MODIFICATION No.: 23143K2664 (Partial) ATA SYSTEM: 21

T I T L E : AIR CONDITIONING - AIR COOLING SYSTEM - INTRODUCE ANTI-ICING VALVE

3 DATE: Nov 20/92 SERVICE BULLETIN No.: A320-21-1065

Location of Anti-Icing Valve Figure 1

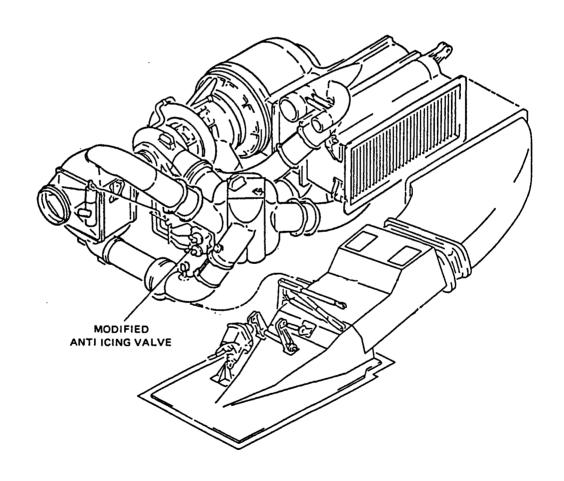
Refer to Figure 1

- (1) Replacement of anti-icing valve.
  - (a) Remove sense lines P/N 778A2900-02, 778A2800-02, 778A2600-01 and 778A3000-02.
  - (b) Remove the anti-icing valve (Ref. AMM 21-61-41, P. Block 401) for modification as per LIEBHERR ABG SEMCA Service Bulletin No. 748A-21-02.

- (c) Install the modified anti-icing valve P/N748A0000-08 (Ref. AMM 21-61-41, P. Block 401).
- (d) Install new sense lines P/N 778A3700-01,778A3900-02,778A4000-01 and 778A3800-01.
